BULLETIN #: 17T-06

SUBJECT: 06E Service Valve Change

Carlyle Compressor is announcing the following update to the 06E (50-99 CFM) suction service valve. This change affects only the models using the 2-1/8" service valves and is effective immediately. Carlyle part number 06EA660091, 2-1/8" ODS, 4-bolt cast iron service valve is now obsolete and will no longer be available for order. The approved Carlyle replacement component is part number 06EA660164, 2-1/8" ODS, 4-bolt brass service valve. This brass service valve kit will include the required gasket and fasteners for assembly to the compressor.

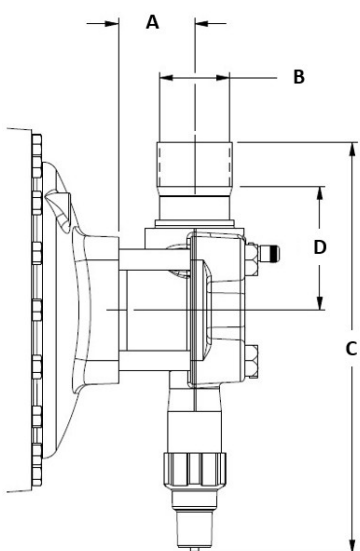
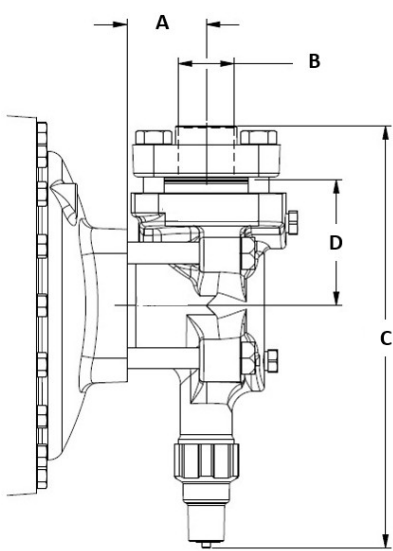
The brass and now obsolete cast iron service valve are identical in function and will not affect compressor performance or reliability. Dimensionally the brass and obsolete cast iron service valves are almost identical in design, making this a low risk change. Compressor mounting will not be affected by the change, however suction line fitment may vary due to the slight change in dimension 'D' shown in the dimensional comparison table.

06EA660164 – Brass Valve

06EA660091 – Cast Iron Valve (obsolete)

During field service replacement of a cast iron service valve to the new standard brass valve, the fasteners cannot be re-used. The brass service valve requires 1/2" longer hex head cap screws. The gasket between the valve and the compressor body is unchanged (part number 6G65-1061). With all sealing components a new gasket should also be used to reduce the risk of leakage.
